# UNITED STATES PATENT AND TRADEMARK OFFICE

APPLICATION NO.	FILING DATE	FIRST NAMED INVENTOR	ATTORNEY DOCKET NO.	CONFIRMATION NO.
10/537,082	01/20/2006	Denis Reibel	331.1095	8094
23280	7590	01/19/2007	EXAMINER	
DAVIDSON, DAVIDSON & KAPPEL, LLC			MAYO III, WILLIAM H	
485 SEVENTH AVENUE, 14TH FLOOR			ART UNIT	PAPER NUMBER
NEW YORK, NY 10018			2831	
SHORTENED STATUTORY PERIOD OF RESPONSE		MAIL DATE		DELIVERY MODE
3 MONTHS		01/19/2007		PAPER

<b>Office Action Summary</b>	<b>Application No.</b>	<b>Applicant(s)</b>	
	10/537,082	REIBEL ET AL.	
	<b>Examiner</b>	<b>Art Unit</b>	
	William H. Mayo III	2831

## **DETAILED ACTION**

FIG. 1

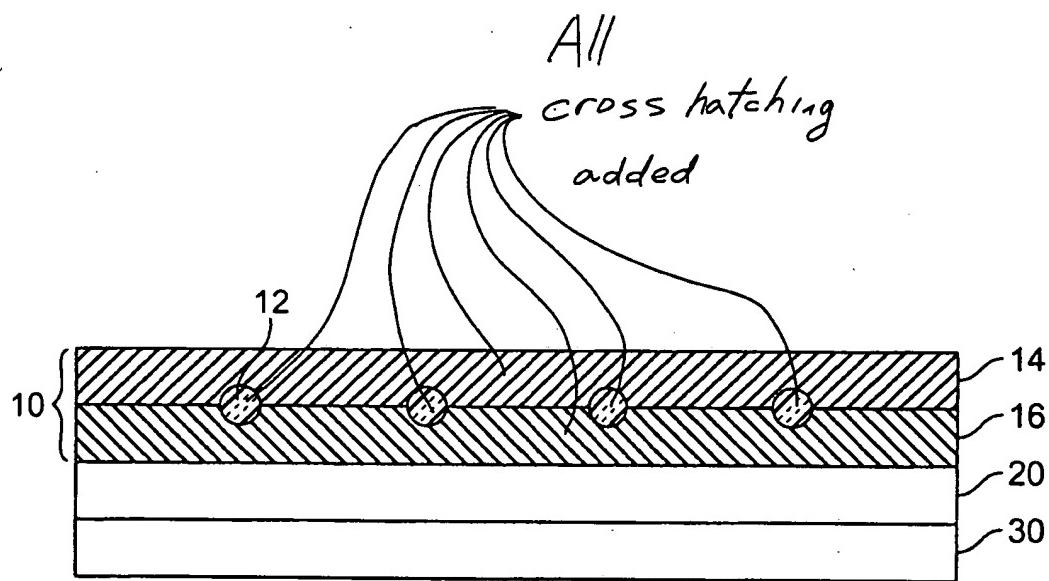
Added  
width  
10/91

- Line quality also  
generally improved
